APPENDIX A: NOTICE OF MODIFICATION

Notice of Modification

The project approval (MP 10_0054) for the Big Island Mining Pty Ltd, granted by the Land & Environment Court of New South Wales on 8 February 2012.

Figure 4
INDICATIVE LAYOUT OF THE APPROVED
HARVESTABLE RIGHTS DAMS

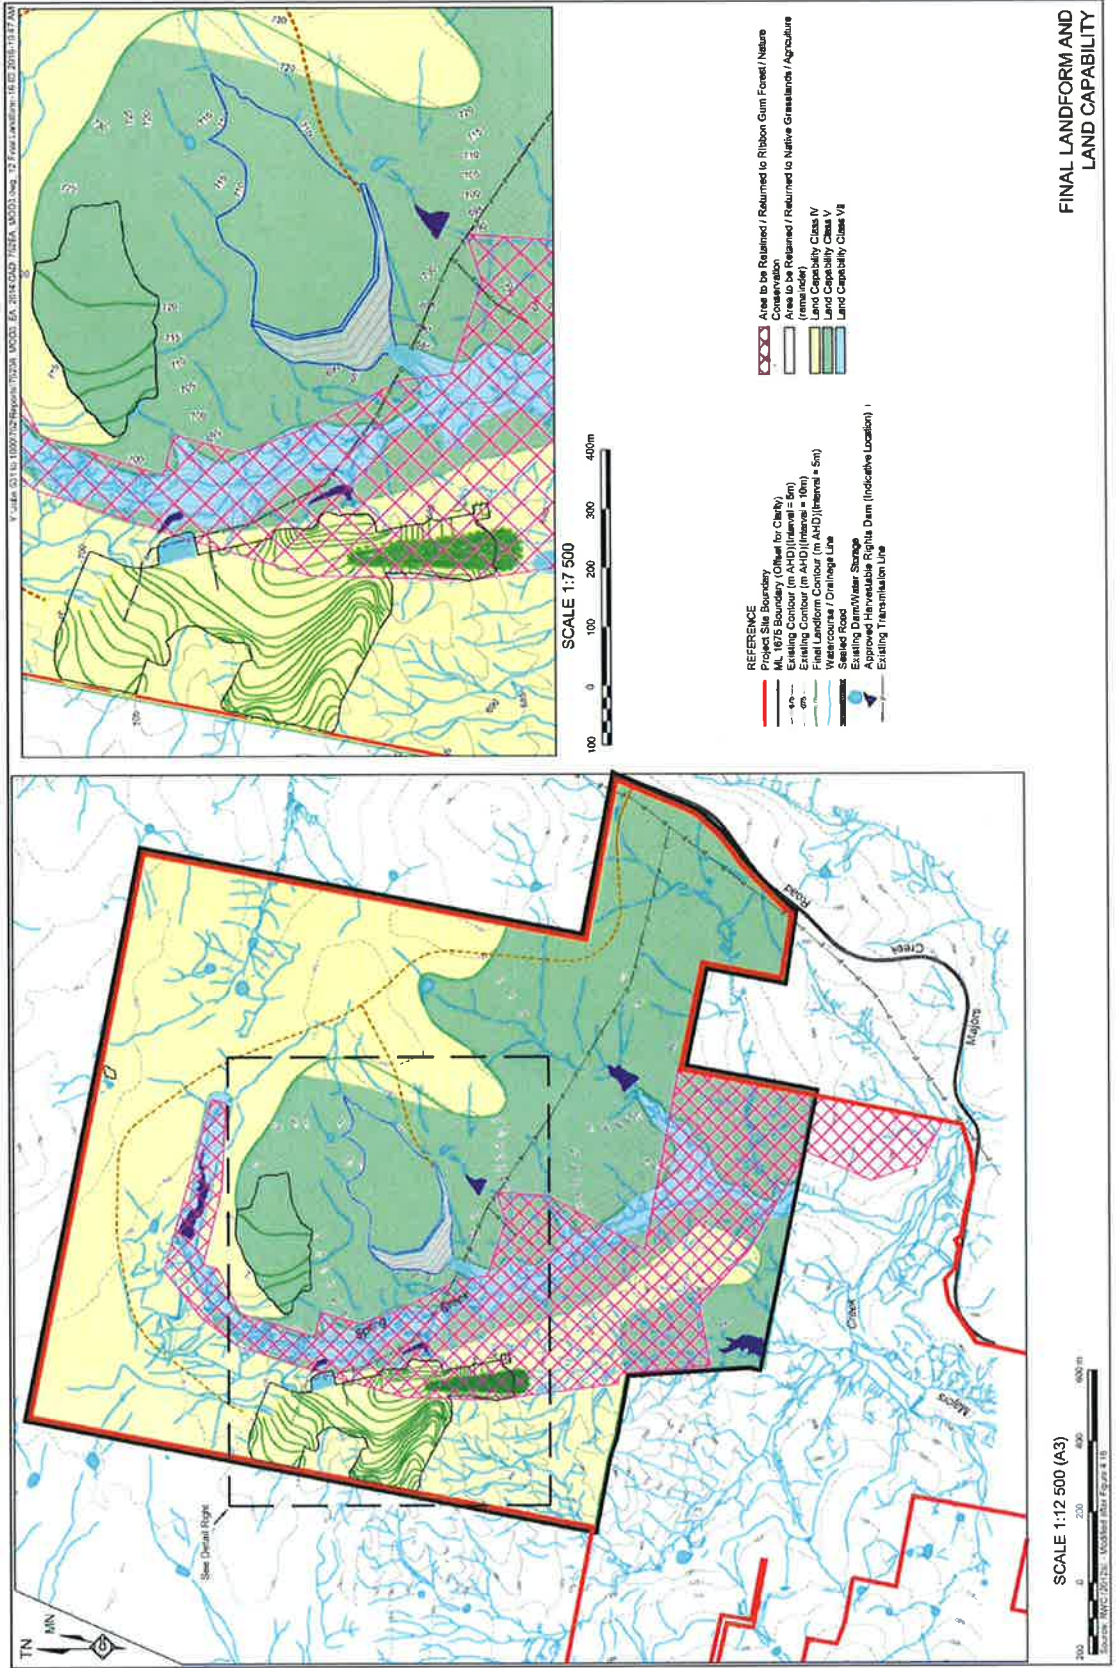
Note: Dams E & F are no longer proposed

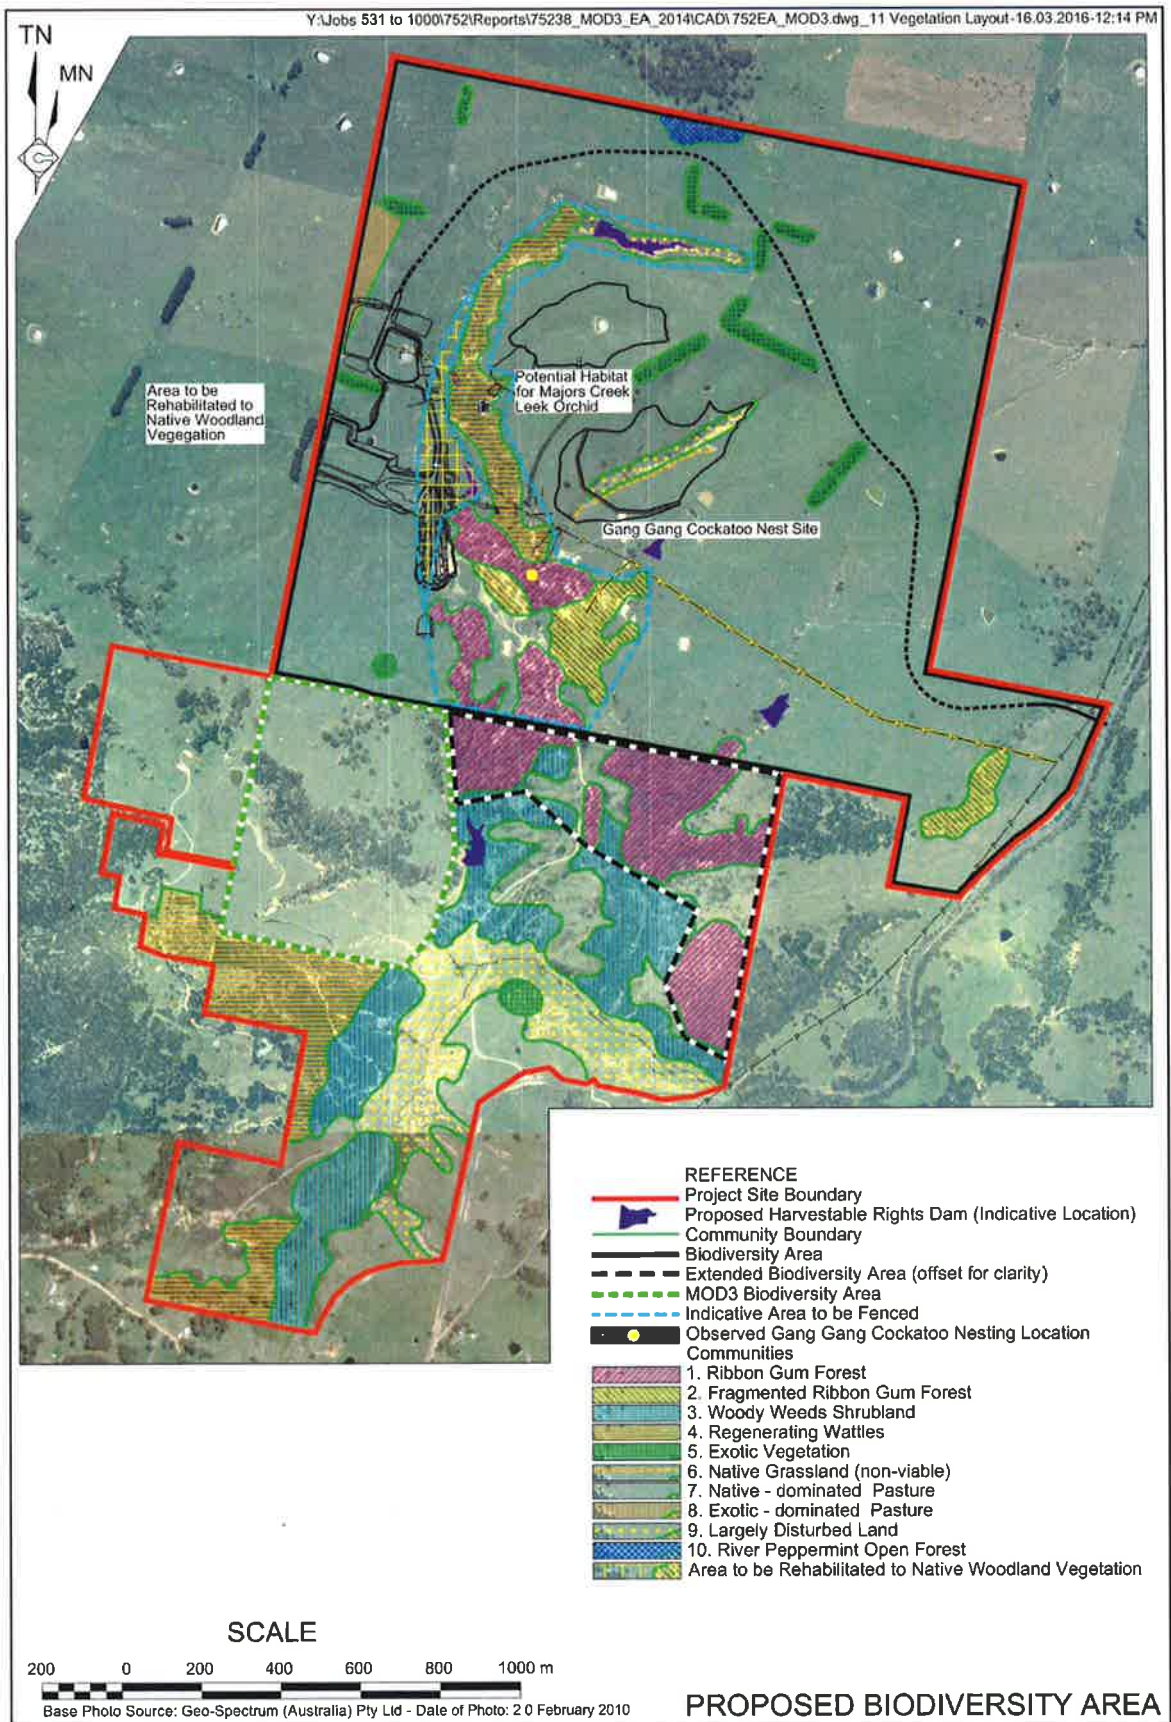
29. In Appendix 3, replace the Figure with the following:
